SUBJECT: Rolls-Royce Response to Request for Additional Information Re: Rolls-Royce Civil Nuclear "**SPINLINE 3** Digital Safety Instrumentation and Control Platform" Topical Report (TAC NO. ME3600)

RESPONSE TO REQUEST FOR ADDITIONAL INFORMATION  
**SPINLINE 3** DIGITAL SAFETY INSTRUMENTATION AND CONTROL PLATFORM  
PROJECT NO. 773

Figure Q1-1: *SPINLINE 3* Chassis - Front View

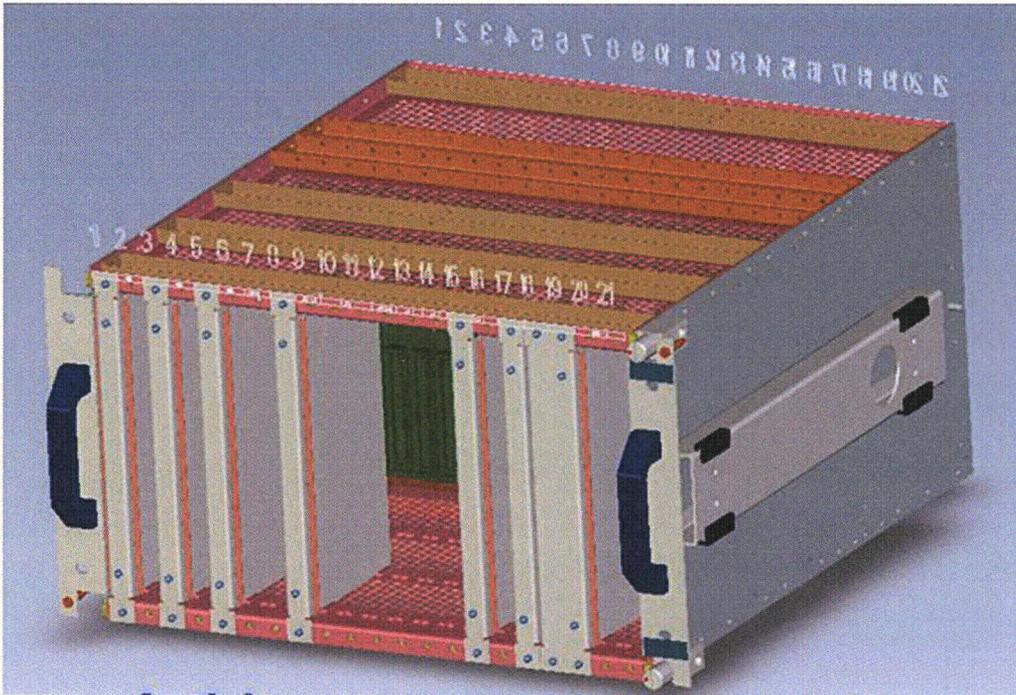
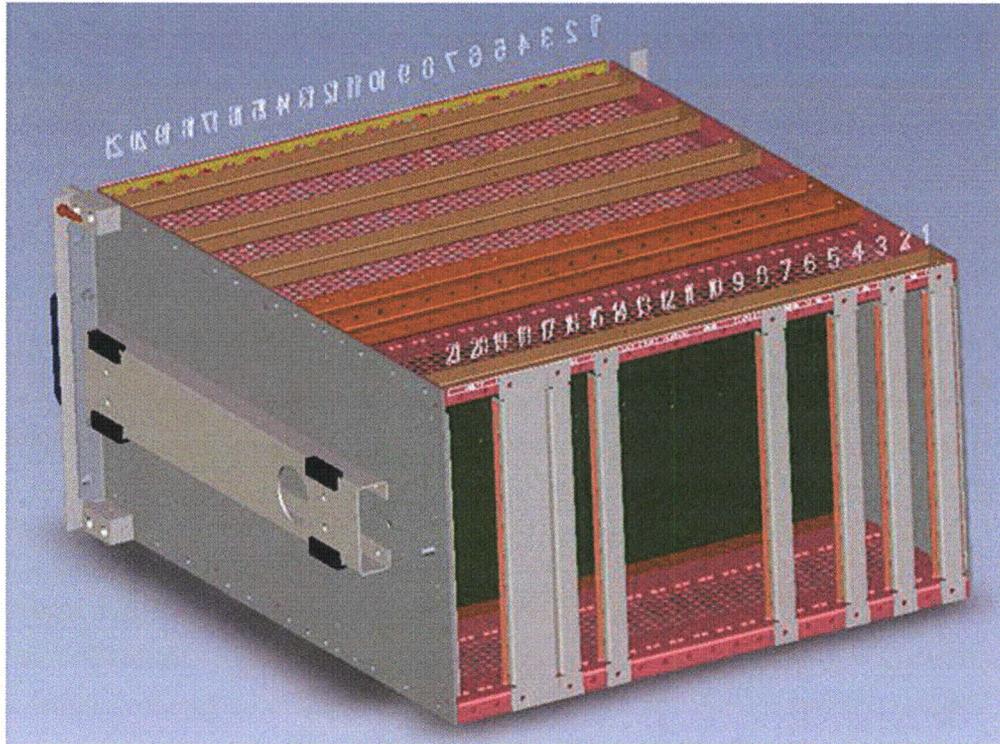
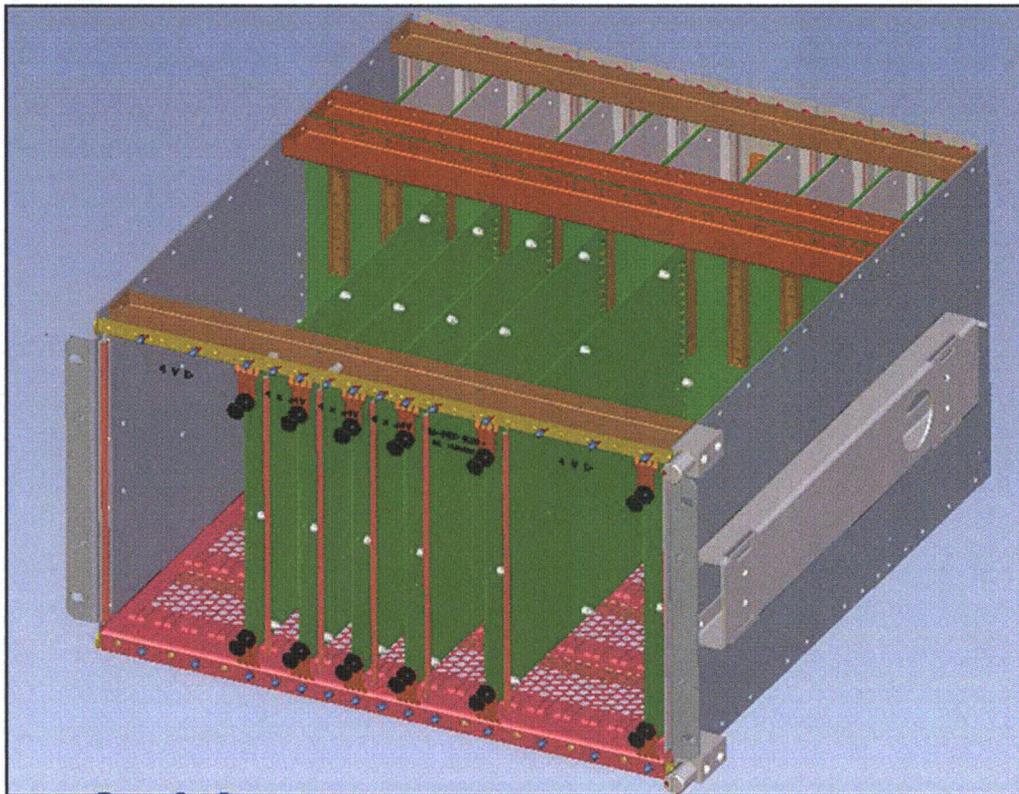
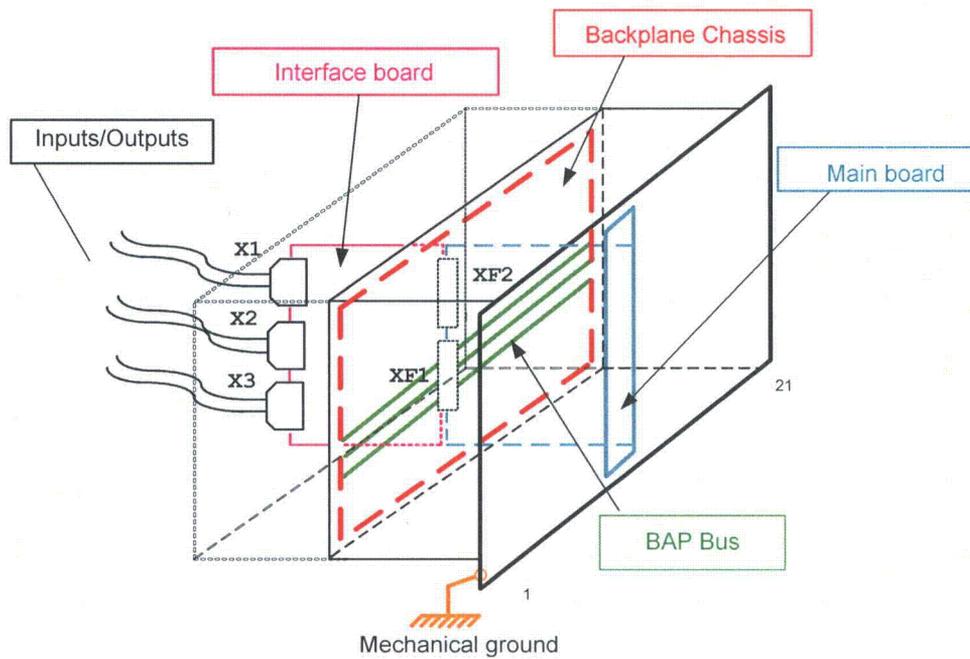
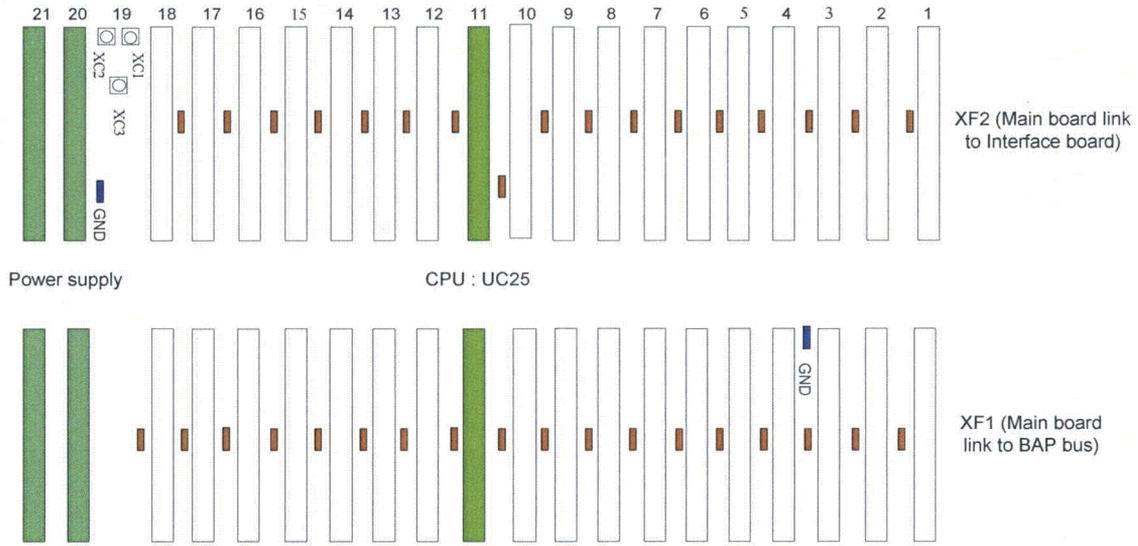
Please provide a specific description of how the SPINLINE 3 components are interconnected. A physical example of the SPINLINE 3 system with a description of how information flows through input board(s), memory locations, backplane(s), processors, a Nervia network and output board(s) (as requested in RAI-4 below) may help facilitate this description.

The backplane fits in the middle of the chassis, in between the main boards and the interface boards. Refer to Figures Q1-1 to Q1-3, which illustrate the mechanical implementation principle with the example of a specific **SPINLINE 3** rack.

The XF2 connectors are not used for the BAP bus. The backplane panel is a physical and mechanical support for the board connectors. It also supports BAP bus because of its central location. Refer to Figure Q1-4.

XF1 connectors are HE 12 / 96 pin fool proof type connectors (H 12D / 32 pins for the power supply); XF2 connectors are HE 12 / 96 pin fool proof type connectors. XC1, XC2, and XC3 connectors (on Figure Q1-5) are power supply board related lugs. Interface boards have standard Sub-D connectors (X1, X2, and X3 on Figure Q1-4) for connection to the rest of the cabinet. The number of Sub-D connectors varies according to the interface board (the 3 connectors on Figure Q1-5 are given as an example).
